CORRIDOR Road Safety Audit

SR 8 / SR 10 / US 23 / US 29 / US 78 / US 278 /
PONCE DE LEON AVENUE NE / SCOTT BOULEVARD
ATLANTA AND DECATUR | DEKALB COUNTY | GEORGIA

Prepared for the Georgia Department of Transportation

Prepared by Gresham, Smith and Partners

FIGURE 5-15. AREA TO STUDY POTENTIAL FEASIBILITY OF CONNECTING SOUTH PONCE DE LEON AVENUE.

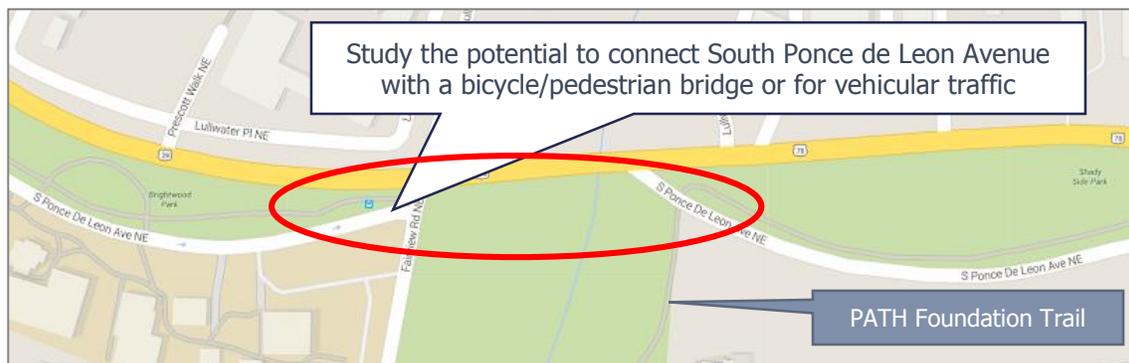
10. Study the feasibility of connecting the two segments of South Ponce de Leon Avenue NE by realigning the two intersections to form a continuous road, without intersecting at Ponce de Leon Avenue (see figure 5-16).	High	High	Long Term	High

FIGURE 5-20. CONCEPTUAL DIAGRAM ILLUSTRATING POTENTIAL CHANGES TO INTERSECTION AT MORELAND AVENUE/US 23/BRIARCLIFF ROAD/SR 42 AND SOUTH PONCE DE LEON AVENUE.

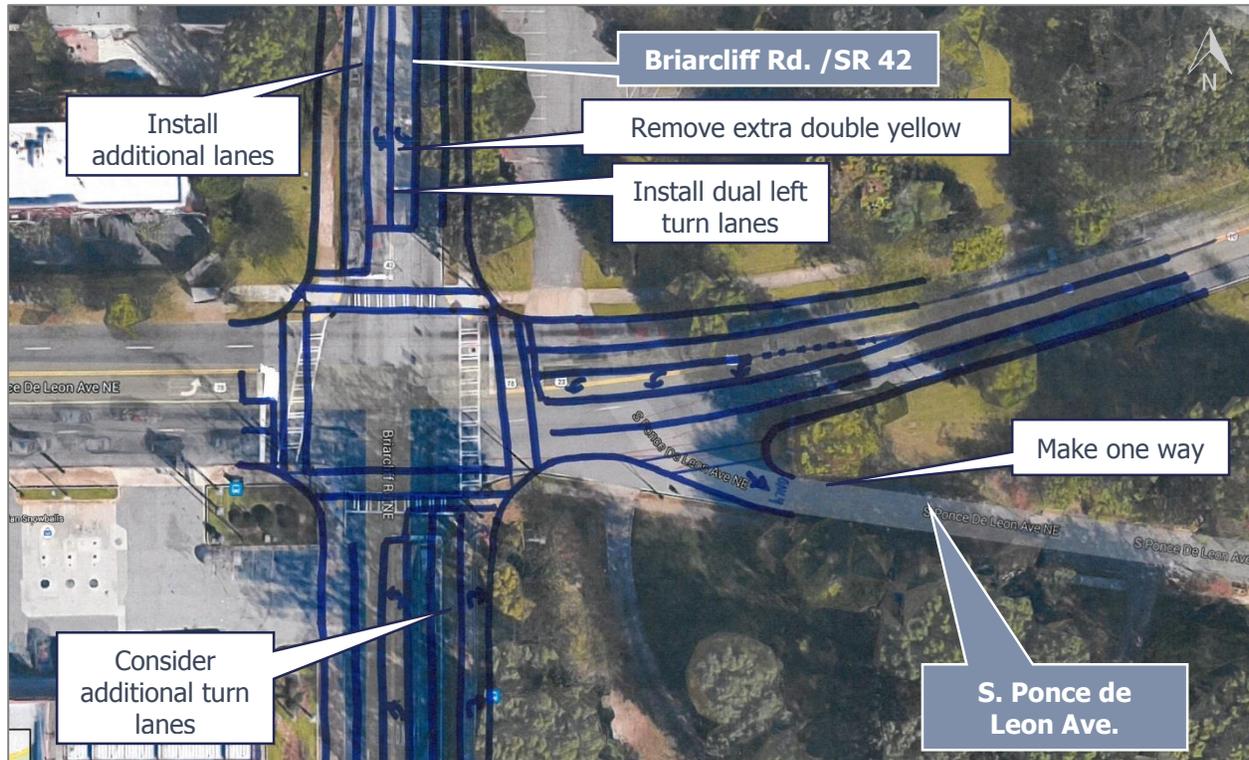
SAFETY BENEFIT	LEVEL OF EFFORT	TIME FRAME	COST
1. Remove the extra double yellow line on Briarcliff Road/SR 42.	Moderate	Low	Short Term	Low
2. Study signal timing for left turn movements and make adjustments as needed to reduce congestion on Moreland Avenue/US 23 and Briarcliff Road/SR 42.	Moderate	Low	Short Term	Low
3. Consider installing sidewalks or relocating paths through Olmsted Linear Park closer to road on south side of the corridor east of South Ponce de Leon Avenue NE. <i>This would be the purview of City of Atlanta and should be done in consultation with the Olmsted Linear Park Alliance.</i>	Low	Moderate	Intermediate	Moderate
4. Redesign intersection and implement full intersection improvement.	High	High	Long Term	High

FIGURE 5-23. SUGGESTED IMPROVEMENTS TO INTERSECTION AT SPRINGDALE ROAD.

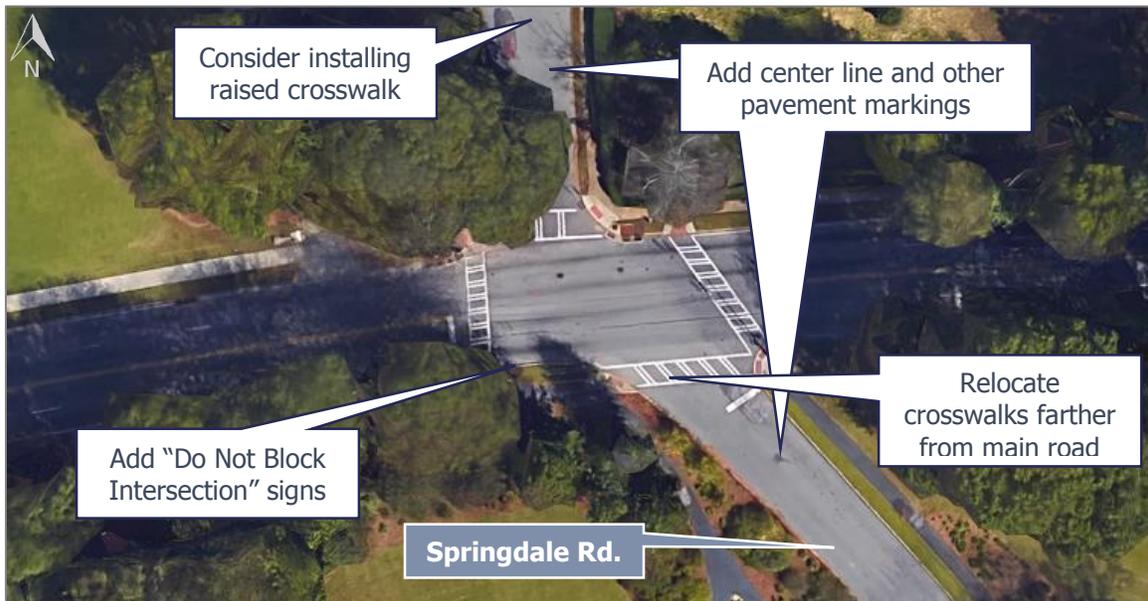
SAFETY BENEFIT	LEVEL OF EFFORT	TIME FRAME	COST
1. Install "Do Not Block the Intersection" (R10-7) signs. (Also in SPARK Travel Plan)	Moderate	Low	Short Term	Low
2. Add center line striping and other pavement markings as needed on Springdale Road.	Moderate	Low	Short Term	Low
3. Trim vegetation as needed to make signals more visible.	High	Low	Short Term	Low
4. Carry out programmed intersection improvement project (PI #0012824) and consider a recommendation from bicycle and pedestrian groups to raise the curb at intersection corners.	High	High	Intermediate	Intermediate
5. Install a raised pedestrian crossing across Springdale Road where the SPARK school path is. This can serve as a traffic calming measure in addition to a pedestrian safety feature. (<i>Note: ensure the raised crossing is fully in the City of Atlanta right-of-way.</i>)	Moderate	Moderate	Intermediate	Low

FIGURE 5-25. SUGGESTED IMPROVEMENTS TO OAKDALE ROAD INTERSECTION.

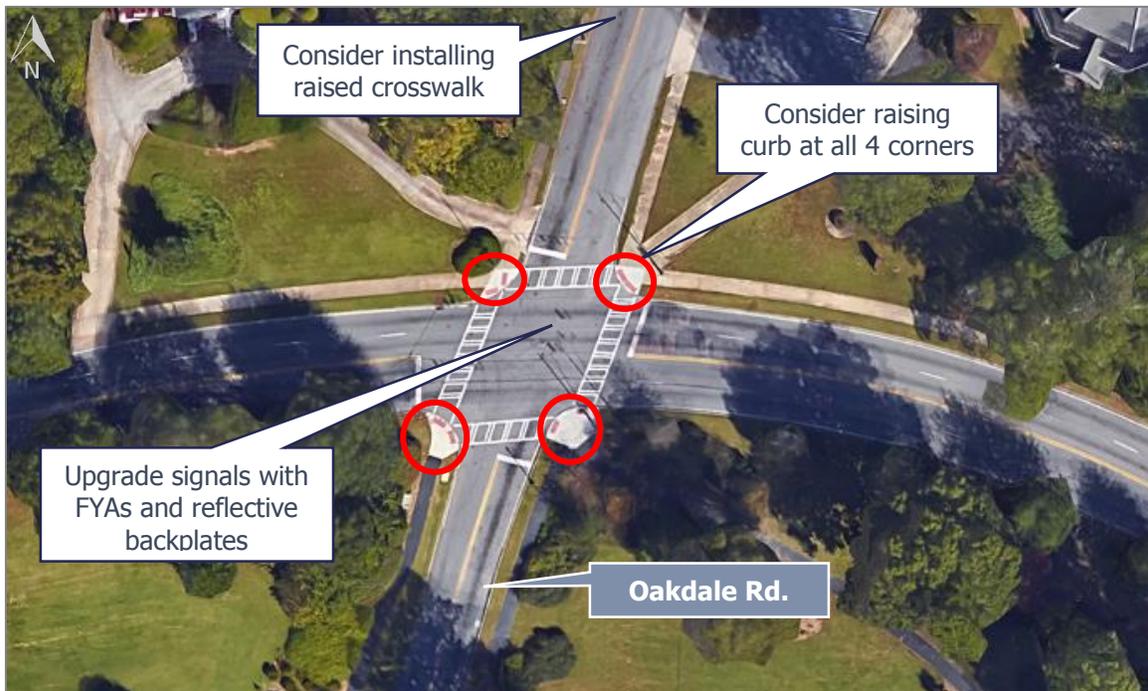
SAFETY BENEFIT	LEVEL OF EFFORT	TIME FRAME	COST
1. Consider a recommendation from bicycle and pedestrian groups to raise the curb at intersection corners.	Moderate	Low	Intermediate	Low
2. Study opportunities to allow better turning movements from Ponce de Leon Avenue NE onto Oakdale Road and implement recommendations as appropriate.	High	High	Long Term	Moderate
3. Install a raised pedestrian crossing across Oakdale Road near St. John's Lutheran Church. This can serve as a traffic calming measure in addition to a pedestrian safety feature. <i>(Note: Ensure the raised crossing is fully in the City of Atlanta right-of-way).</i>	Moderate	Low	Intermediate	Low

FIGURE 5-30. SUGGESTED IMPROVEMENTS TO LULLWATER ROAD/FAIRVIEW ROAD.

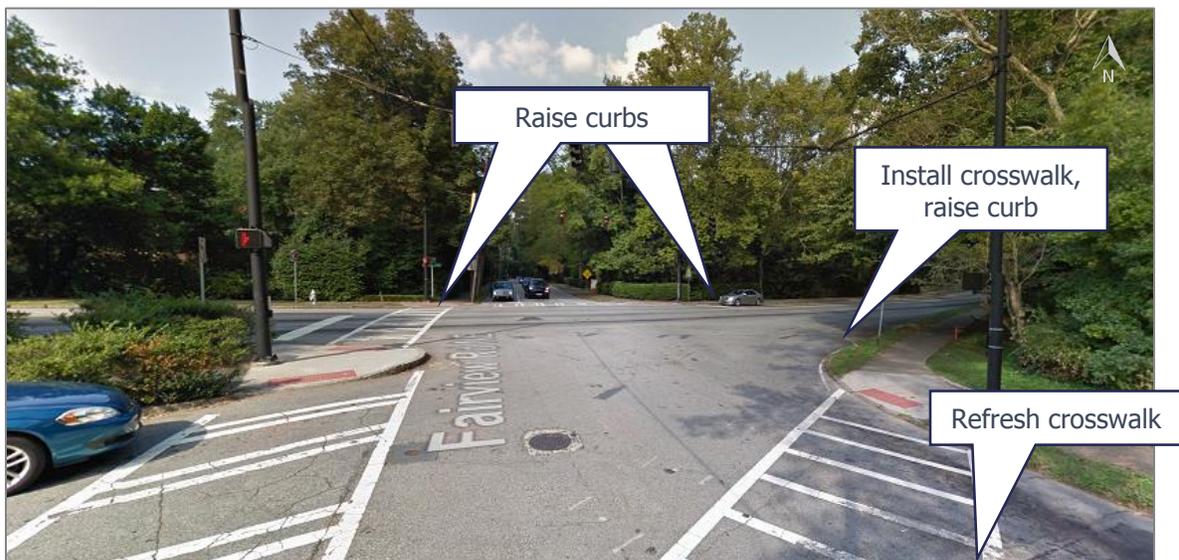
SAFETY BENEFIT	LEVEL OF EFFORT	TIME FRAME	COST
1. Refresh and install crosswalks as needed, including on east side.	High	Low	Short Term	Low
2. Carry out intersection improvement project (PI #0012824) and install working pedestrian push buttons.	High	Moderate	Intermediate	Moderate
3. Consider a recommendation from bicycle and pedestrian groups to raise the curb at intersection corners.	Moderate	Low	Intermediate	Low
4. Install a guardrail along the bridge on Ponce de Leon Avenue NE.	High	Low	Intermediate	Moderate
5. Install more "No Turn on Red" signage.	High	Low	Short Term	Low

FIGURE 5-33. SUGGESTED IMPROVEMENTS TO THE INTERSECTION AT THE WESTERN END OF THE SECOND SEGMENT OF SOUTH PONCE DE LEON AVENUE AT PONCE DE LEON AVENUE NE (NEAR LULLWATER ESTATE).

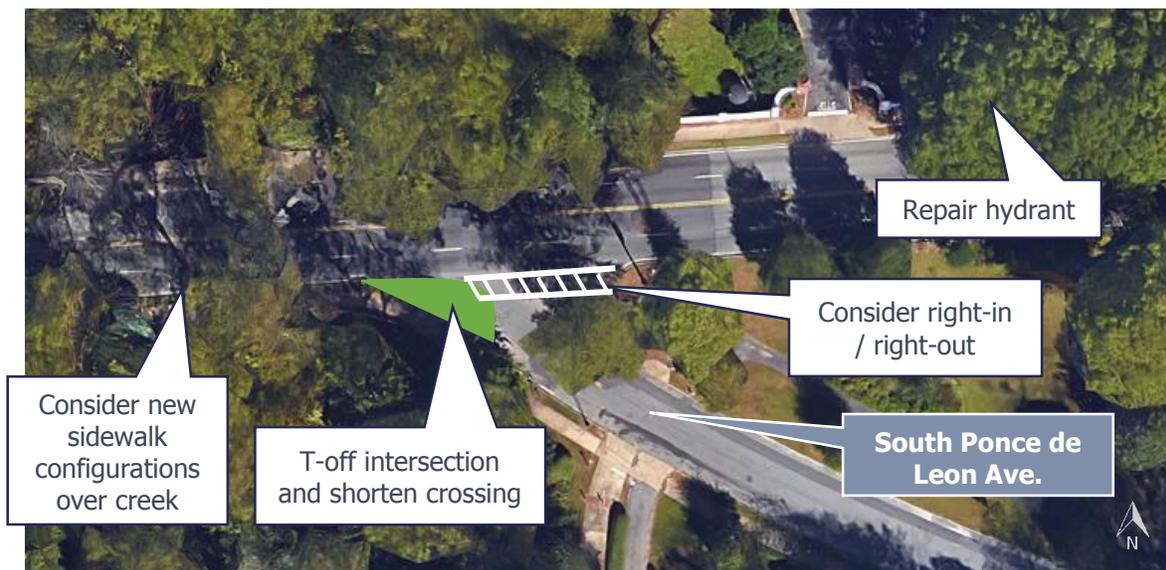
SAFETY BENEFIT	LEVEL OF EFFORT	TIME FRAME	COST
1. Remove damaged and incorrect school zone sign.	Low	Low	Short Term	Low
2. Coordinate with the Paideia School to permit school zone and sign appropriately.	Moderate	Low	Short Term	Low
3. Study the feasibility of expanding the shoulder or relocating the sidewalk farther from travel lanes at the bridge over the creek, west of South Ponce de Leon Avenue, and implement if possible.	High	Moderate	Long Term	High
4. Repair the fire hydrant.	Low	Low	Short Term	Low
5. Consider redesigning the intersection as right-in/right-out on South Ponce de Leon Avenue NE.	High	Moderate	Long Term	Moderate
6. Install bulb-out to T-off intersection and shorten pedestrian crossing.	High	Moderate	Intermediate	Moderate

FIGURE 5-39. SUGGESTED IMPROVEMENTS TO CLIFTON ROAD INTERSECTION.

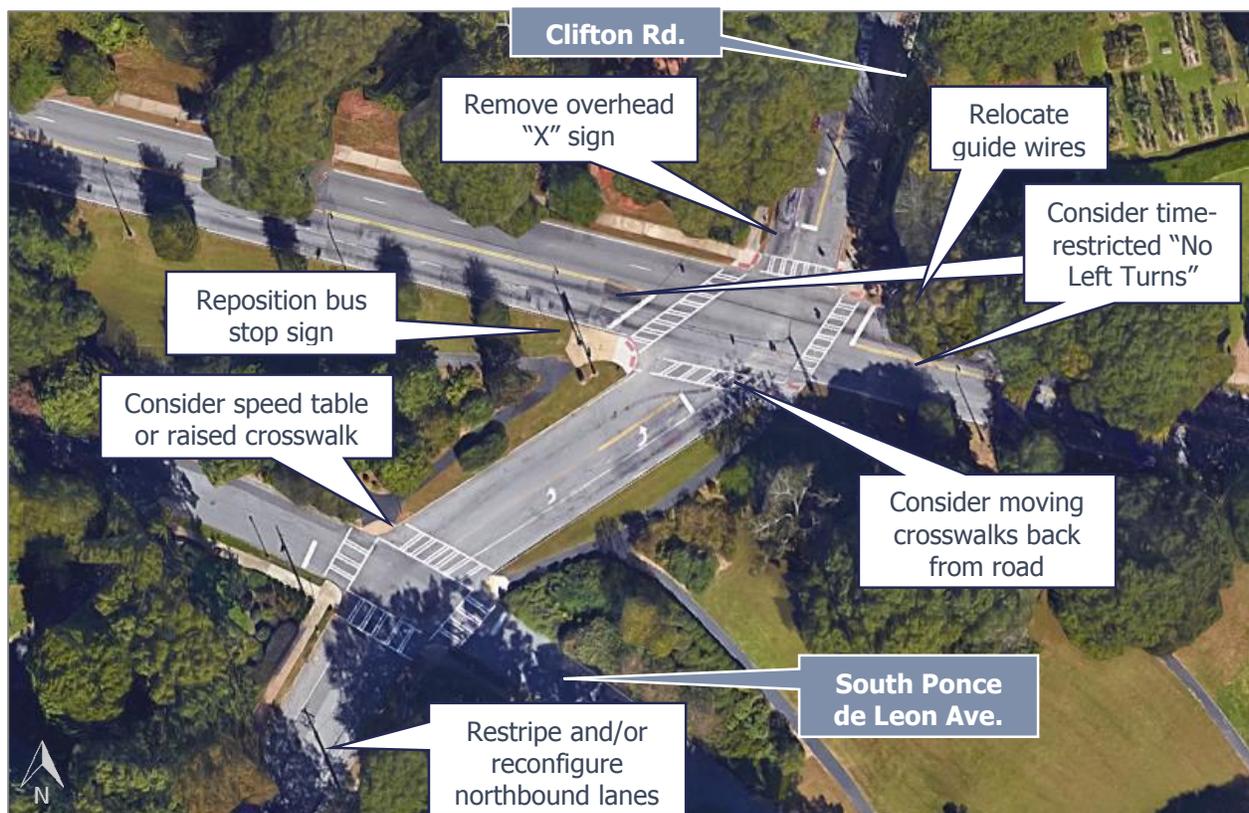
Many community survey comments express concern about the difficulty and high incidence of crashes when turning left onto Southbound Clifton. Many expressed that consideration should be given to time-restricted prohibition of left turns and use of other streets for access to southbound Clifton Road.

5. Work with the City of Atlanta to repair or replace the light pole in the southeast quadrant.	High	Low	Short Term	Low
6. Remove the overhead red "X" sign in the southbound lane of Clifton Road that may be confusing to northbound drivers.	Moderate	Low	Short Term	Low

11. Evaluate the feasibility of redesigning the intersection to more closely conform to Frederick Law Olmsted's original plan for Druid Hills, including a possible roundabout at Clifton Road and Ponce de Leon Avenue NE.	High	High	Long Term	High

12. Consider time-restricted "No Left Turns" at Clifton Road.	High	Moderate	Short Term	Low

FIGURE 5-42. SUGGESTED IMPROVEMENTS AT THE EAST END INTERSECTION OF SOUTH PONCE DE LEON AVENUE AND PONCE DE LEON AVENUE.

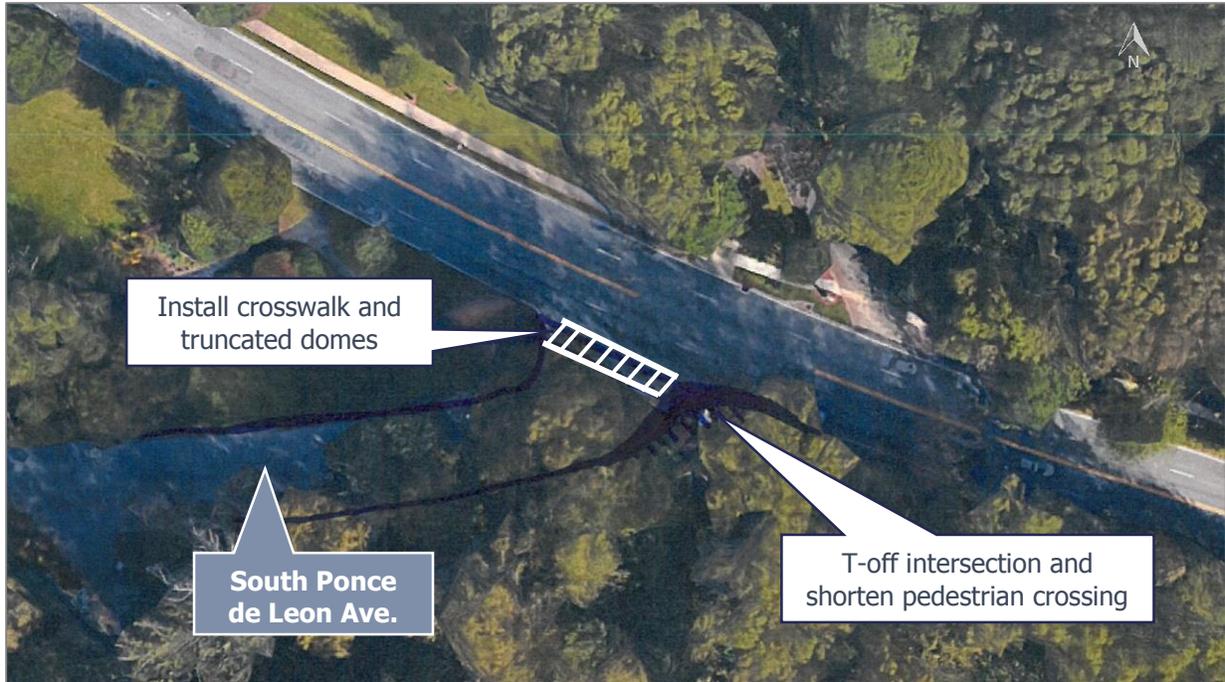
SAFETY BENEFIT	LEVEL OF EFFORT	TIME FRAME	COST
1. Install a bulb-out to square or T-off the intersection and shorten the pedestrian crossing distance.	High	Moderate	Intermediate	Moderate
2. Refresh and install pavement markings and lane striping as needed.	High	Low	Short Term	Low
3. Relocate stop bar and stop sign closer to intersection.	High	Low	Short Term	Low
4. Install pedestrian facilities including crosswalk and truncated domes.	High	Low	Short Term	Low

FIGURE 5-46. SUGGESTED IMPROVEMENTS TO INTERSECTIONS AT NORTH PONCE DE LEON AVENUE AND LAKESHORE DRIVE.

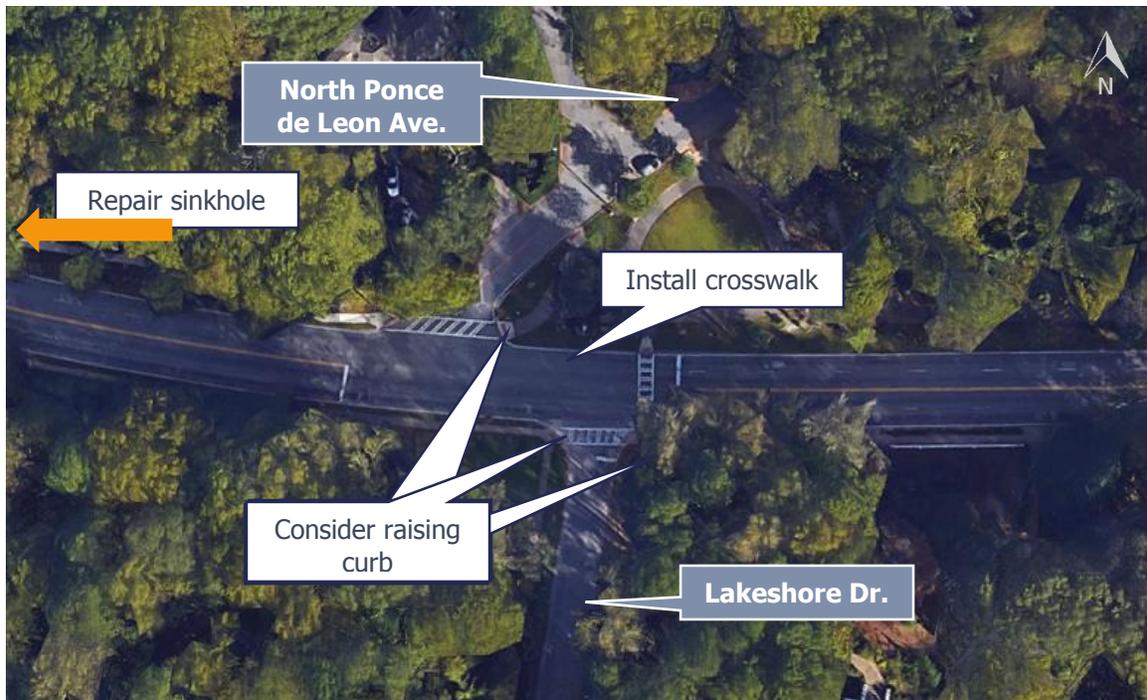
SAFETY BENEFIT	LEVEL OF EFFORT	TIME FRAME	COST
1. Investigate the driveway at 1820 Ponce de Leon Avenue NE and bring into conformity as needed. Rebuild curb.	Low	Low	Short Term	Low
2. Install crosswalk on west leg of intersection.	High	Low	Short Term	Low
3. Investigate and repair the sinkhole as needed.	Moderate	Low	Intermediate	Moderate
4. Install a new guardrail on the north side of Ponce de Leon Avenue NE.	High	Low	Short Term	Low
5. Consider a recommendation from bicycle and pedestrian groups to raise the curb at intersection corners.	Moderate	Low	Intermediate	Low
6. Study the feasibility of tying the intersections at North Ponce de Leon Avenue and at Lakeshore Drive together with a new intersection design. Implement design recommendations if feasible.	High	High	Long Term	High

FIGURE 5-60. SUGGESTED IMPROVEMENTS FOR THE EAST END OF NORTH PONCE DE LEON AVENUE.

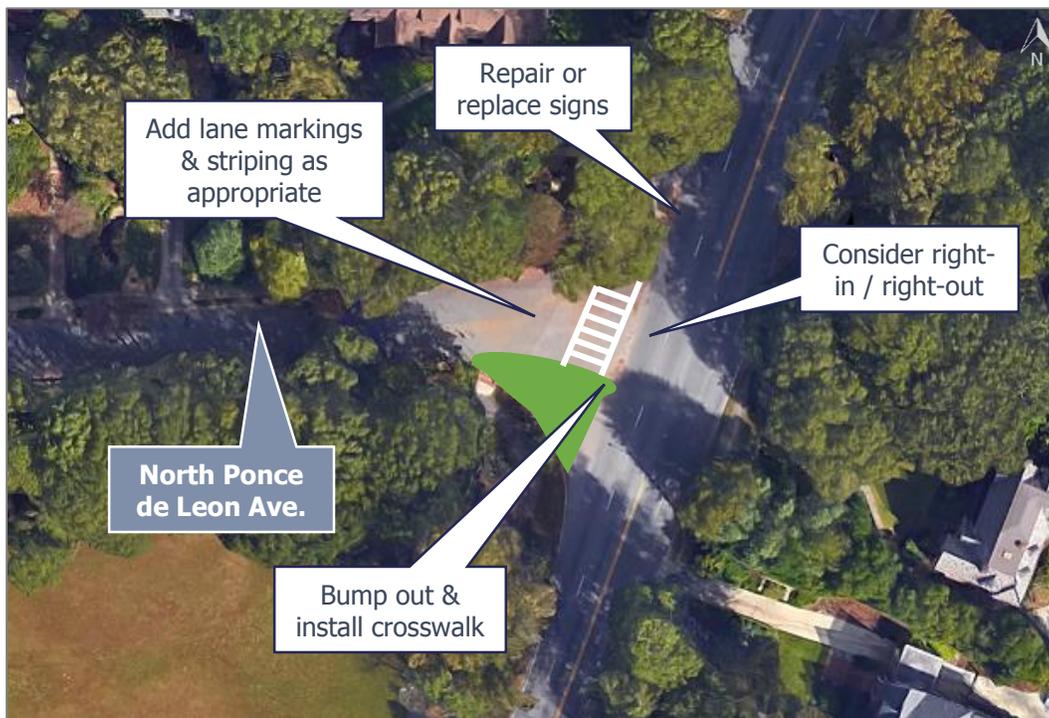
SAFETY BENEFIT	LEVEL OF EFFORT	TIME FRAME	COST
1. Shorten the distance for pedestrians to cross North Ponce de Leon Avenue.	High	Moderate	Intermediate	Moderate
2. Study the feasibility of converting this intersection to a right-in/right-out only.	High	Low	Short Term	Low
3. Install new eight inch edge lines and/or raised pavement markers.	High	Low	Short Term	Low
4. Repair or replace sign pole as needed.	Moderate	Low	Short Term	Low
5. Study ways to reduce the width of the opening of the intersection such as constructing a bulb-out of the curb (into North Ponce de Leon Avenue) and additional landscaping. Implement recommendations as appropriate.	Moderate	Moderate	Intermediate	Low

FIGURE 5-66. SUGGESTED IMPROVEMENTS TO ARTWOOD ROAD AND AROUND RAILROAD TRESTLE.

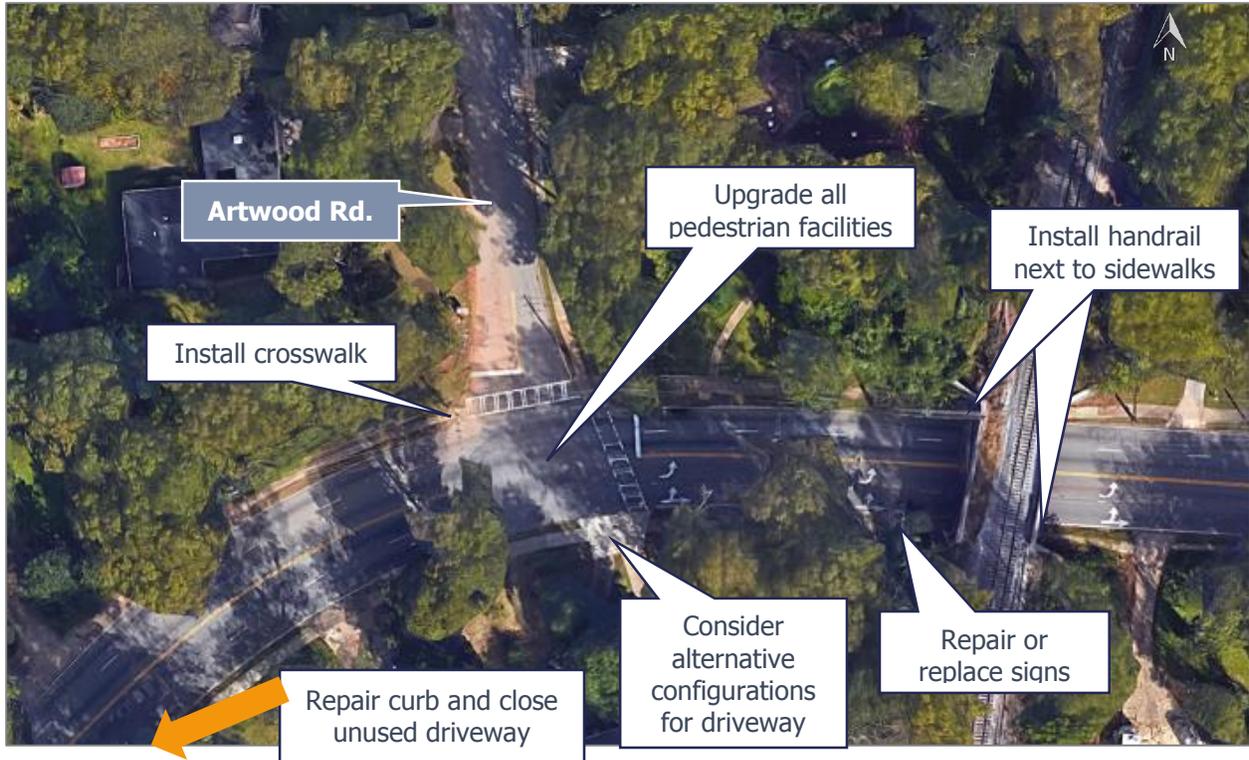
2. Investigate and repair or replace pedestrian countdown signal as needed.	High	Low	Short Term	Low
3. Trim vegetation to reduce sign blockage.	High	Low	Short Term	Low

5. Repair or replace sign posts and poles as needed.	Moderate	Low	Short Term	Low
6. Study opportunities to reconfigure the driveway on the northeast quadrant so that it is not in the middle of the intersection.	Moderate	Low	Short Term	Low

8. Consider installing handrail or railing between travel lanes and sidewalk underneath bridge overpass.	High	Low	Intermediate	Low
9. Repair or replace flashing signals on east side of the railroad bridge.	High	Low	Short Term	Low

10. Install new bridge clearance signage on the bridge and in advance of the bridge as appropriate.	High	Moderate	Short Term	Low
